ADDENDUM NO. 4

Issue Date: January 26, 2024

Project Name: Sandridge Golf Club New Clubhouse

ITB Number: 2024029

A001 Symbols & Abbreviations

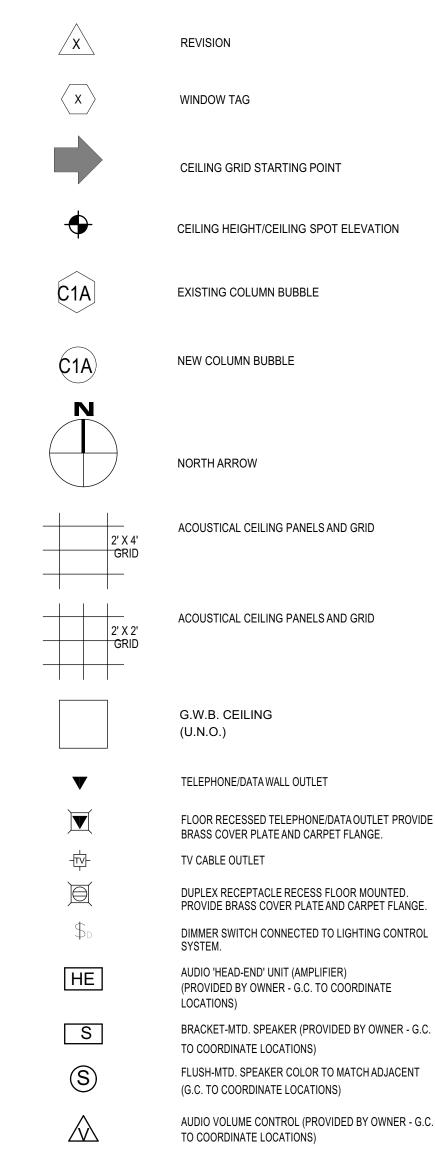
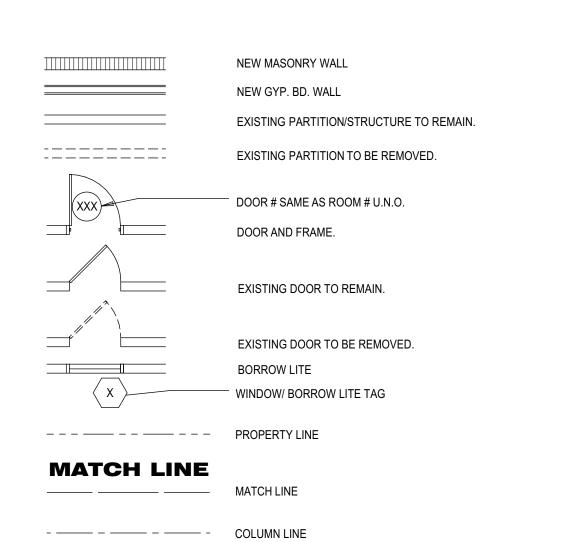
Kitchen equipment will now be Owner Furnished, Contractor Installed

REPLACE A001 NOTICE TO BIDDERS with attached A001 Symbols & Abbreviations

REFER TO CONSTRUCTION DOCUMENTS BY OTHERS FOR THE FOLLOWING WORK WHICH IS OWNER FURISHED, OWNER INSTALLED. INCLUDED IN THE BID SET FOR COORDINATION.
